Chapter 6: Analysis of Wire Degradation

RSC Analysis

RSCs for McDonnell Douglas DC-9 Aircraft⁸

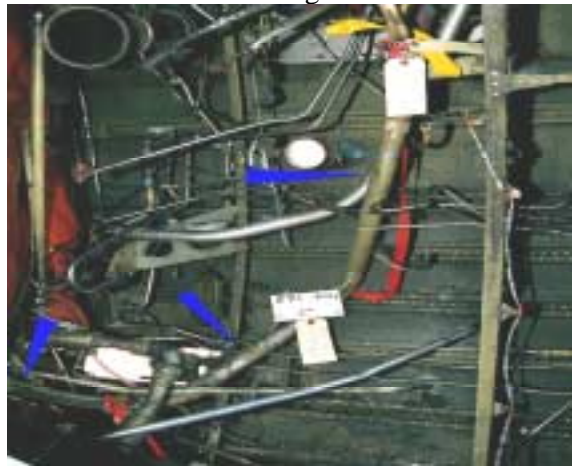
2. DC-9 Wire is Spiral Wrap: along vertical braces to either side of the aft stair there are small wire bundles protected by spiral wrap. Upon removal of the spiral wrap one inspector noticed that the several of the wires were burnt from apparent wire-to-wire arcing. (The exterior of the spiral wrap was not scorched.) The arcing may have been the result of chafing induced by the spiral wrap.

4. DC-9 Power Feeder Cable in Conduit: Lectromec testing identified a breached power feeder cable within a conduit. The cable was not visually inspectable. Subsequent laboratory analysis found a charred area on the cable indicating electrical shorting or severe overheating.

5. 747 Power Feeder Cable Chaffing: An inspector noticed that one two power feeder cables crossing each other at a 60 degree angle was chaffed through to the core. The other power feeder cable did not appear damaged. The cables had no mechanical fastener at or near the point of crossing and contact. The chaffing was most probably caused by vibration and relative motion during operation of the aircraft.

6. A300 Polyimide Delamination: Apparent localized delamination of several wires was discovered during laboratory visual examination. Though there was no field indication on the specimen, other wires in the area were noted as being contaminated with toilet fluid. One of these wires was identified by Lectromec's field and subsequent lab testing as being breached to the conductor. Laboratory analysis of the bundle showed that several wires had partially delaminated and degraded polyimide insulation. (See Appendix 4.2.1)

7. L1011 Circuit Breaker Panel Wiring: An inspector noticed that two wires leading to circuit breakers had traumatic damage that probably resulted from the wire's being pinched between the swing-down panel and adjacent fixed panel. Over-length wire or improper routing is the most likely cause of the damage.

Boeing is aware that relative motion between wires with differing insulation abrasion characteristics will result in wear to one or both of the affected wires. For this reason Boeing recommends that relative motion between the wires be eliminated or, if that is not possible, installation of protection between the wires. In-service experience has indicated that wrapping of wire bundles and proper clamping at the wire bundle attachment points prevents relative wire motion between different wire specifications within the same wire bundle. In the case of two different wires or wire bundles crossing at an angle on the same plane, as in the case of the Roswell 747, Boeing specifies the installation of abrasion protection on one of the wire bundles and tying of the bundles together to protect against abrasion and to reduce relative motion. Boeing does not believe that the Roswell 747 exhibited the concern of insulation wear as a result of installing different wire specifications within the same wire bundle. We believe that the use of present installation practices as outlined in the SWPM would have prevented the noted chafing.

1. Service Bulletin 093-24-109 address's circuit breaker wiring that was reported to be chafing against a circuit breaker terminal. This SB can be revised to include the same solution for all wiring contained within circuit breaker panels, provide inspection criteria and instructions for repair and securing of the wiring.
2. Create a Service Bulletin that address's the specific discrepancy and provides a solution.

Figure 5: Sample 8-9

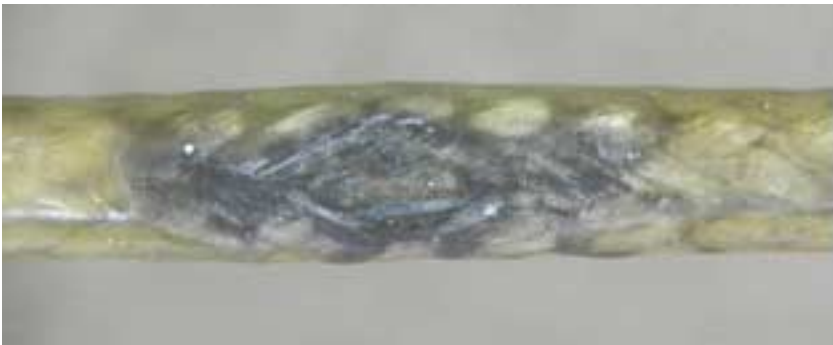
Sample 8-9 (SRC #3): Sample 8-9 did exhibit some surface damage (Figure 5). Experience with the previous samples suggests that this damage was probably insufficient to cause excessive current leakage. Like Sample 8-1 this wire contained a mechanical splice similar to that in Figure 4. The splice was found to be the source of excessive current leakage.
